CERTIFICATE OF APPROPRIATENESS

Property: 7610 Rockhill Street, Lot 28, Block 40, Glenbrook Valley Neighborhood Subdivision. The property includes a historic 2,111 SF one-story wood single-family residence and attached garage situated on an 8,050 SF interior lot.

Proposal: Alteration - Windows

Recommendation: Denial - does not satisfy criteria 1 and issuance of COR requiring reversion to inset aluminum windows

BEFORE AND AFTER – WINDOW 1

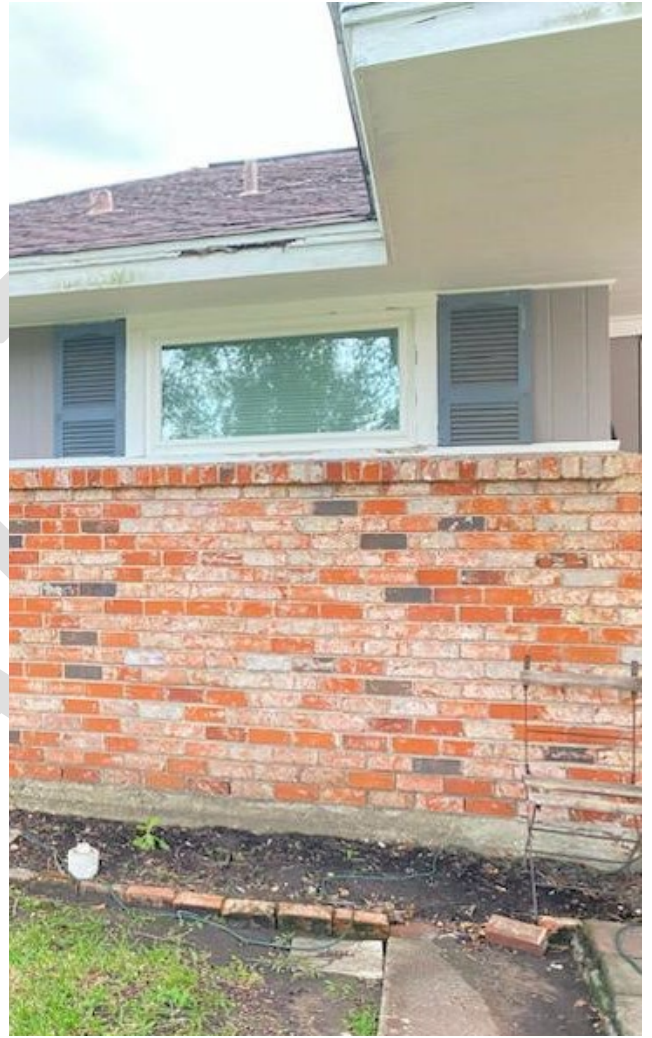
- 311 complaint and building inspector at site, 11/7/2023
 - Unpermitted work for windows
- A total of 2 red tag notices between 11/2023 to 12/2023 with follow-up visits by inspector
 - Most recent inspector follow-up on 12/18
- Scope of work includes:
 - Replacement of 6 original aluminum, inset windows to vinyl, recessed Morfe windows
